Report to the Future Melbourne (Planning) Committee

Ministerial Planning Referral TPM-2015-40 915 Collins Street (No. 1 Collins Wharf) Docklands 17 May 2016

PLANNING REPORT

Application number: TPM-2015-40

Image 3. Setbacks

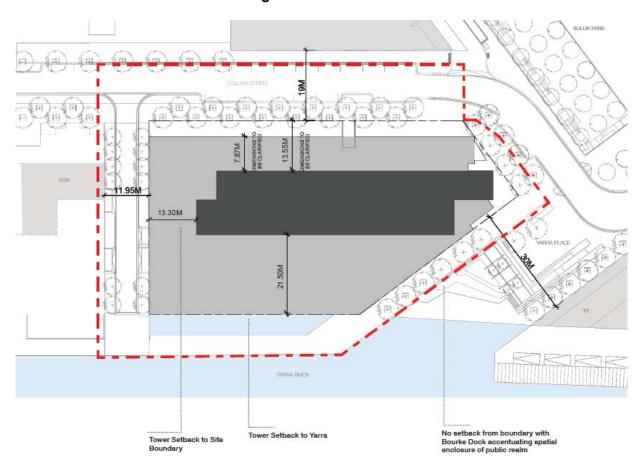
Referring to Image 4 above, the proposed setbacks of the tower are 13.5m from Collins Street (North), 21.5m from the south (Yarra River), 13.3m from the west (Dock Lane East) with reduced setbacks from the east (Bourke Dock) but increasing as the height of the building increases.

The reduced setbacks for the Bourke Dock interface are also supported, subject to no adverse wind or overshadowing implications for this public open space (discussed below). From a design perspective, the alignment of the tower component of building at this interface being on an angle reflects the triangular shape of the eastern part of site, being the junction between the City Quarter and Wharf Quarter of Victoria Harbour (and also the junction of Collins Street and Bourke Dock). The slender tower form, which steps back from level 16, is considered an appropriate response to the unusal shaped parcel of land, at a location which is identified as a landmark site (discussed below). The tower has been designed 'in the round', and would positively address Collins Street and Buluk Park (as evidenced by the perspective images provided by the applicant – see Image 4 below).
